IMPORTANT NOTICE

Re: Adjustment of the Transmitter's charger circuit.

Engineering Department,
Brainstorm Electronics, Inc.

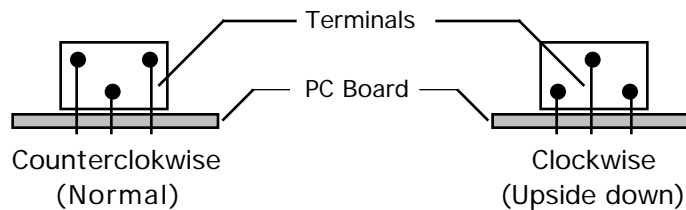
1. Open the transmitter (unscrew the back cover - do not detach the PC board).
2. Locate potentiometer (B) - You will see two blue potentiometers: a bigger one (A) on the bottom side of the card near the battery and a smaller one (B) on top of the card closer to the front panel. The smaller one is the one that needs to be adjusted.
3. Turn the screw of pot B counterclockwise exactly one and a quarter turn ($1 \frac{1}{4}$).

(Note: This potentiometer has three terminals soldered to the circuit board. Normally, the middle terminal is closest to the PC board (see side view below). However, a few units have the pot soldered upside down. If you come across such units, the adjustment needs to be $1 \frac{1}{4}$ turn clockwise instead of counterclockwise).
